Subject: **Vermont Yankee Nuclear Power Station
Technical Specification Proposed Change No. 263 – Supplement No. 33
Extended Power Uprate – Response to Request for Additional Information**

Proposed Technical Specification Change No. 263 – Supplement No. 33

Response to Request for Additional Information

Figure EMEB-B-77-1 – Sheet 1: VYNPS Main Steam Piping Cavities and ACM Measurement Locations

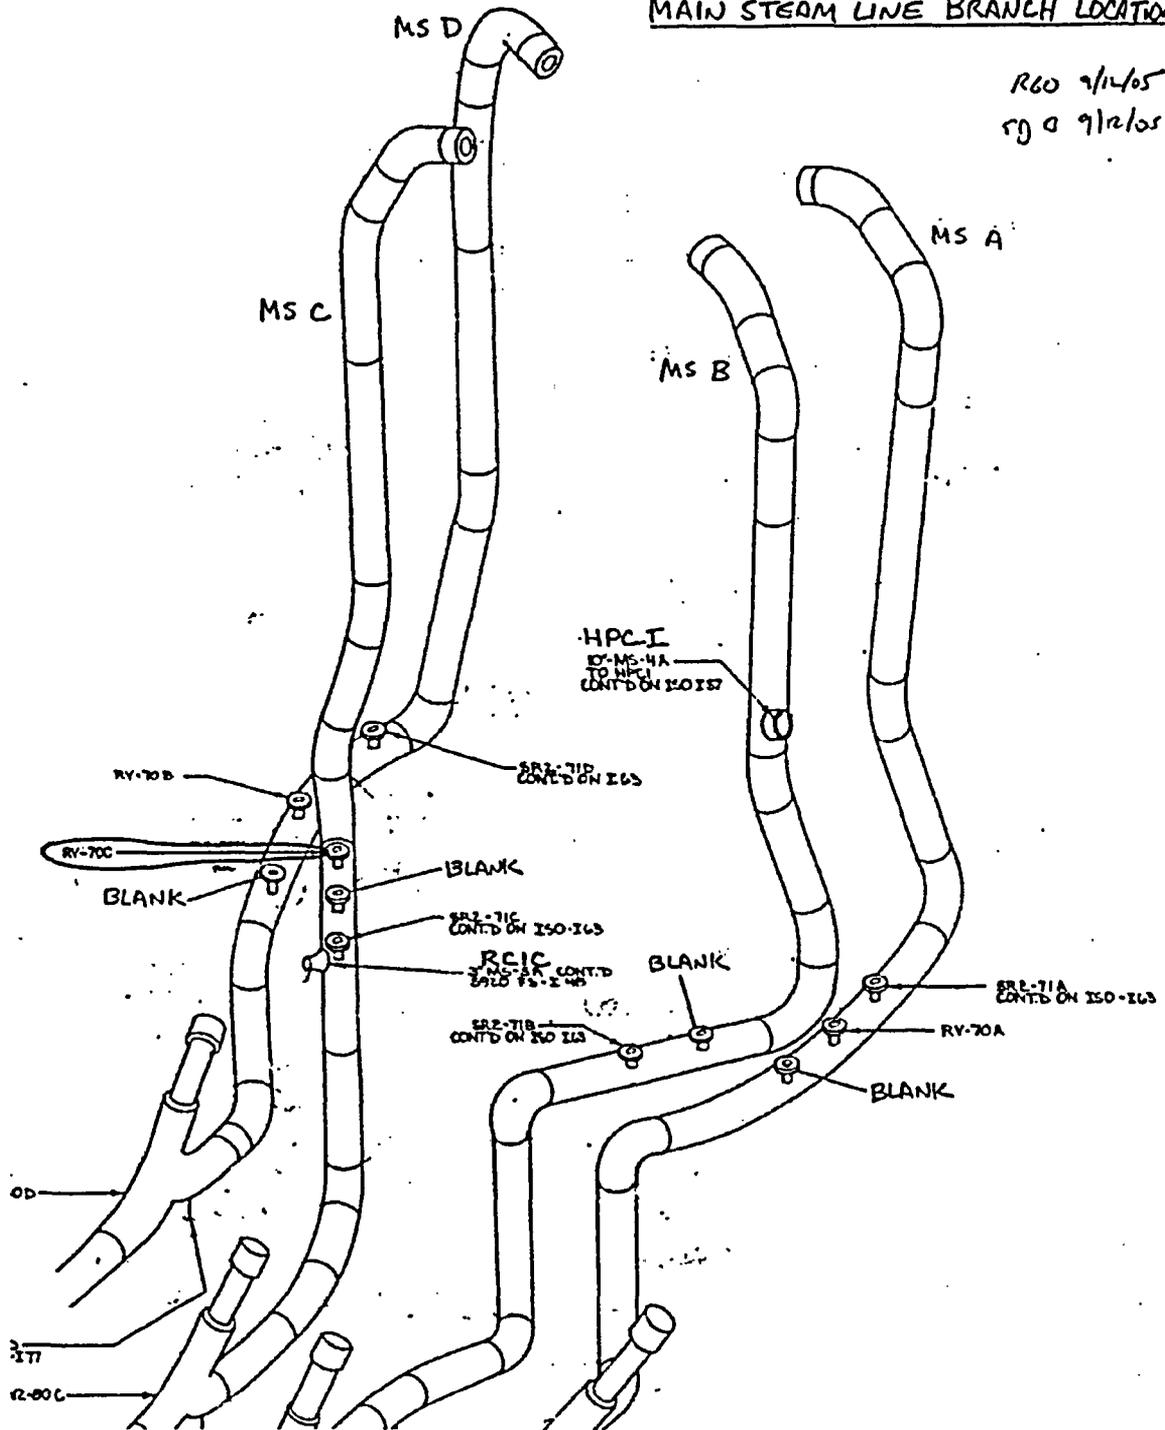
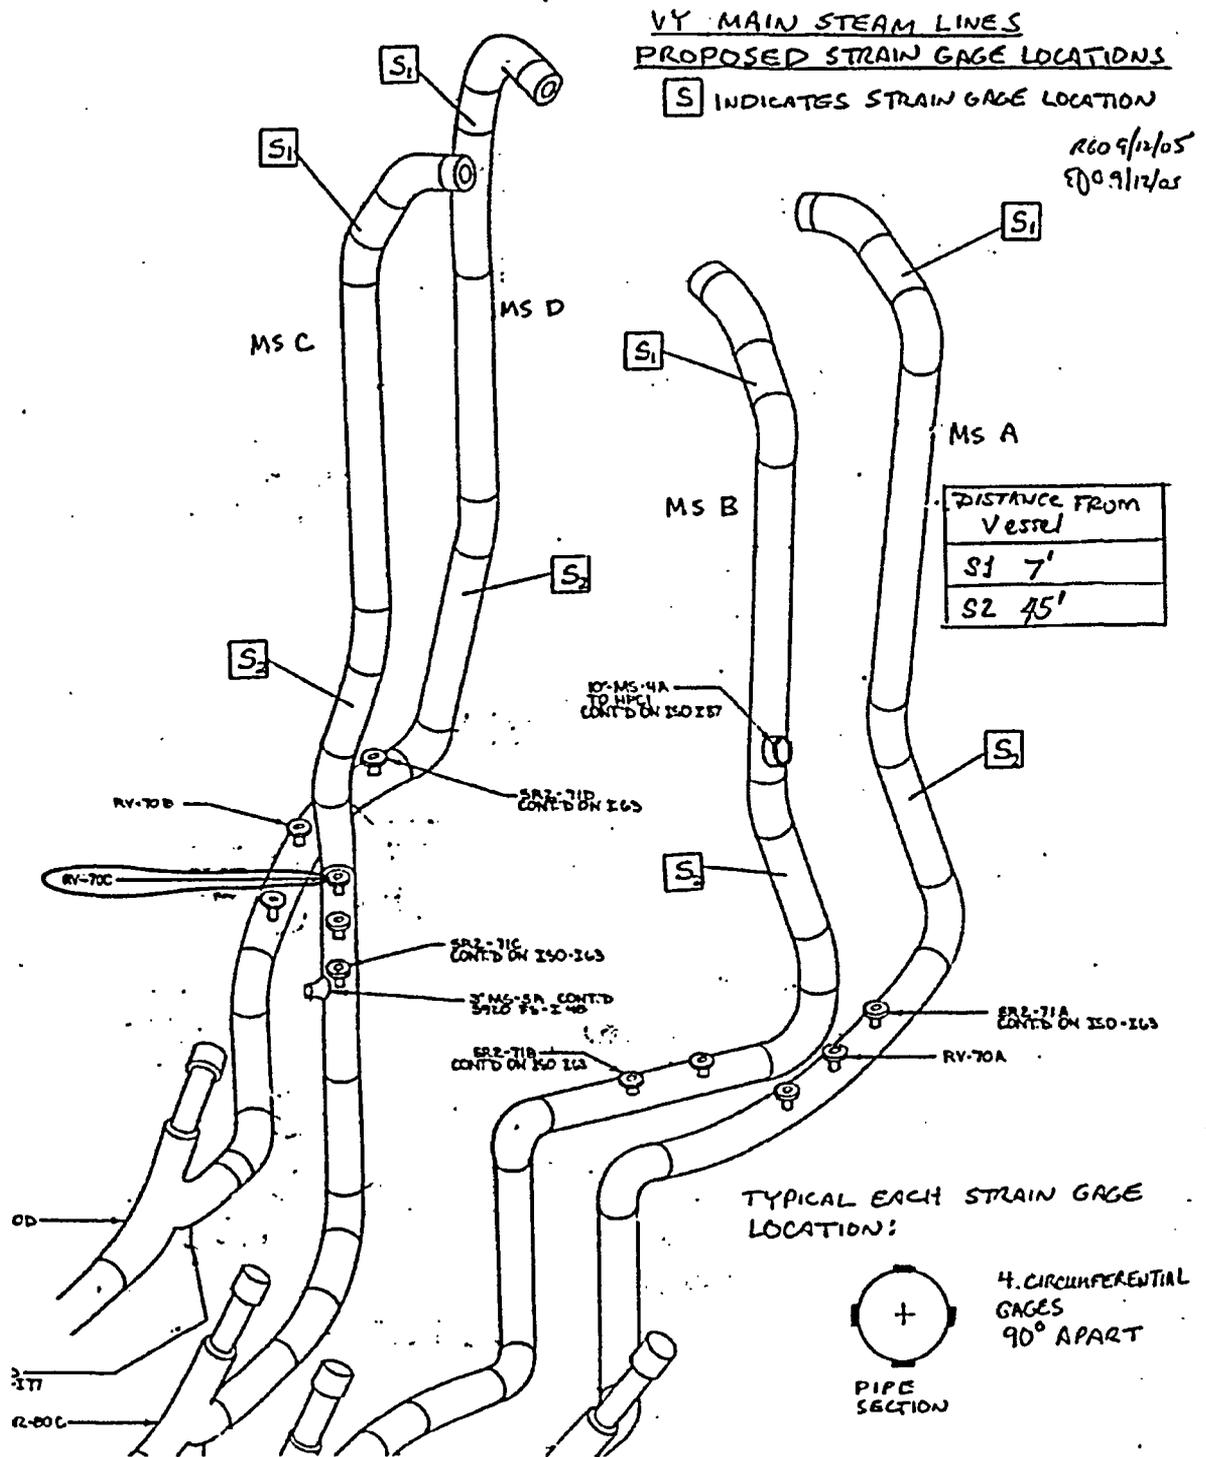
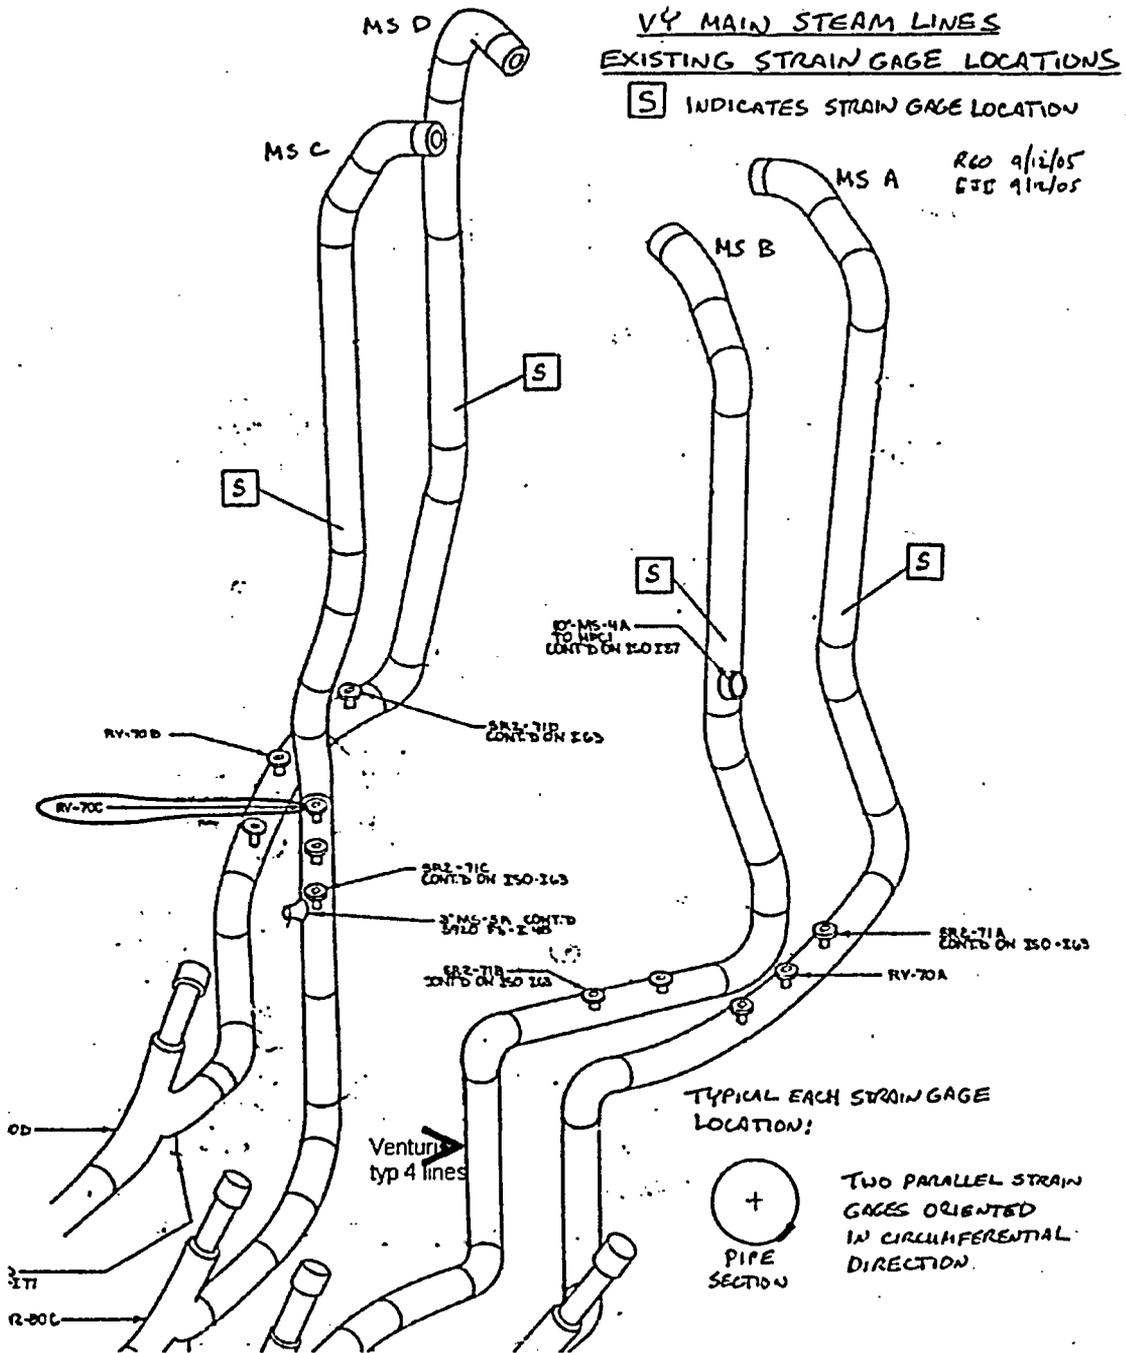
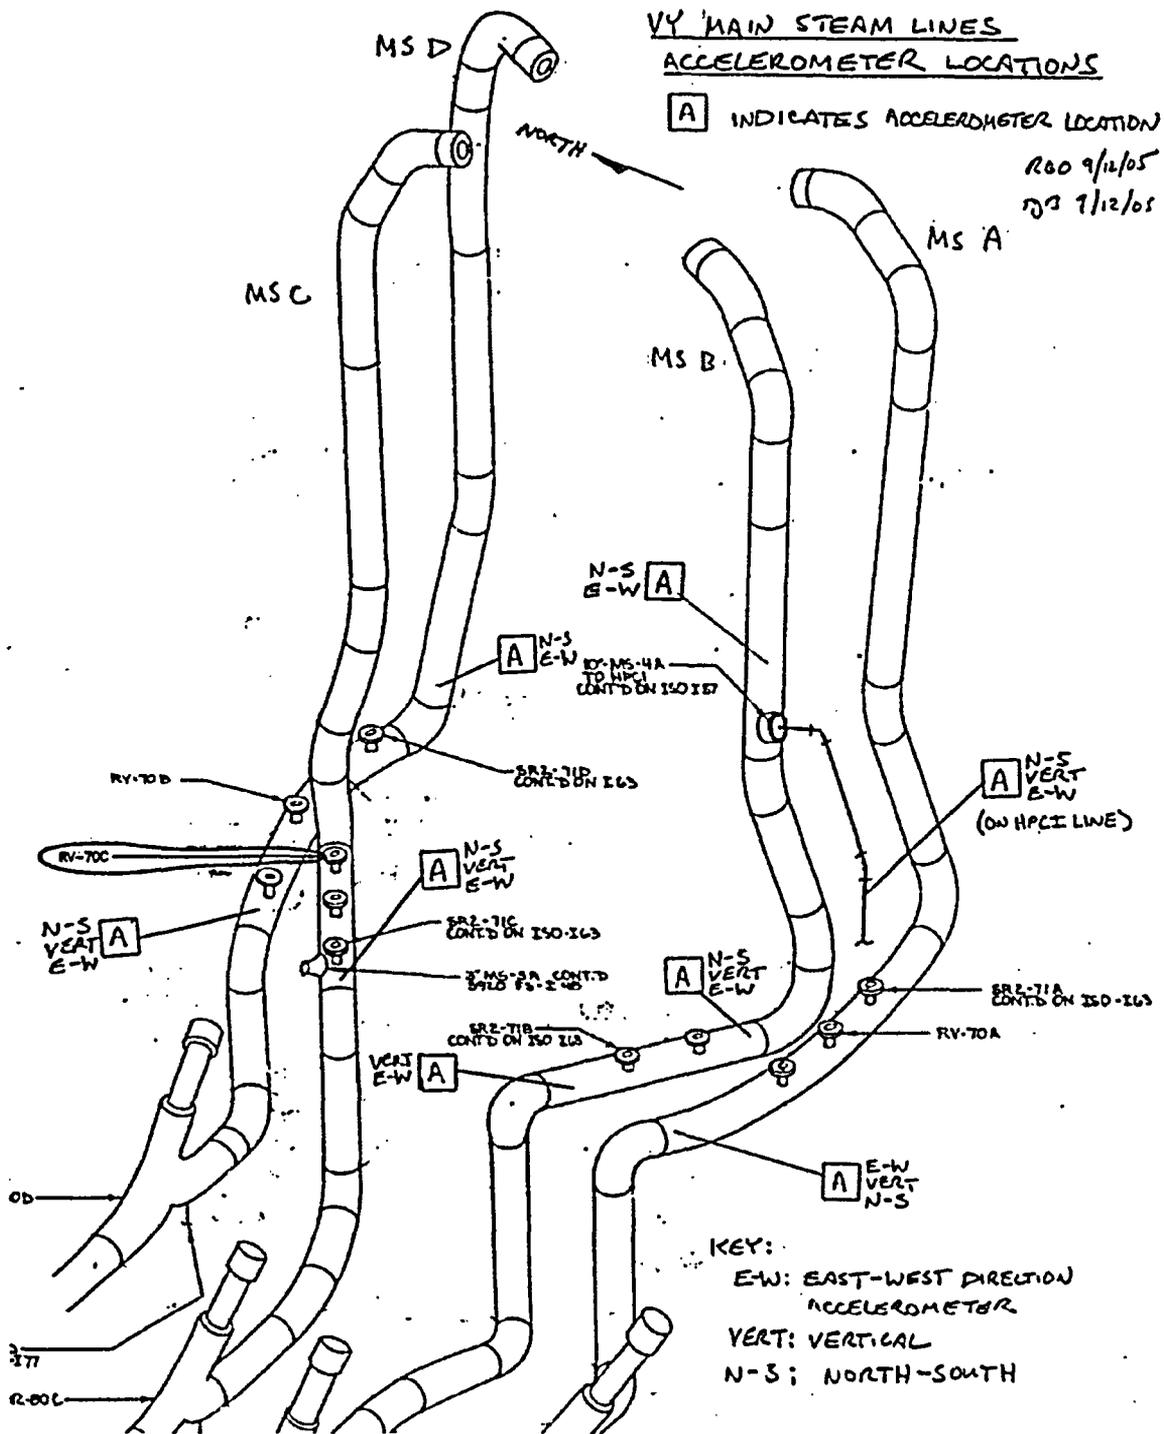
The Executive Summary of NEDC-33192P (Conclusions 8 - 10 for Plant Data and Conclusion 2 for SMT) mentions that existing data from VYNPS MSL strain gauges and venturi lines show no evidence of any “singing” in downstream valves. In other BWR-3 plants, and in the GE SMT data, singing in valves has been observed, and can lead to high acoustic pressure loads on the steam dryer. Entergy should explain whether there is a potential of acoustic pressure loads (on the dryer) induced by valve singing between pre-EPU and EPU conditions, and provide any estimates of valve singing frequencies (with respect to power level).

7. A more comprehensive evaluation of potential VYNPS main steam system acoustic resonators in vortex shedding frequencies is provided in the revised response to RAI EMEB-B-77 in Attachment 3. Included in this response revision is a drawing showing the relative locations of VYNPS main steam system cavities (potential resonators), ACM input measurement locations and piping FIV monitoring accelerometers.

Entergy evaluated the potential acoustic source frequencies in the VYNPS main steam lines by estimating the natural frequencies of known cavities and the shear wave instabilities caused by steam flow over the cavity openings. Figure EMEB-B-77-1 sheet 1 shows the location of the VYNPS main steam line cavities including Safety Relief Valves (SRV's), Spring Safety Valves (SSV's), HPCI steam supply line and RCIC steam supply line. In addition, sheet 2 shows the location of the proposed location for the additional 32 strain gages, sheet 3 shows the location of the measurement locations used as input to the VYNPS acoustic circuit model, and sheet 4 shows the locations of the accelerometers for FIV monitoring. Appendix 1 contains Entergy's evaluation of the potential cavity resonant frequencies and comparison to the calculated vortex shedding frequencies at both current licensed thermal power and EPU conditions.
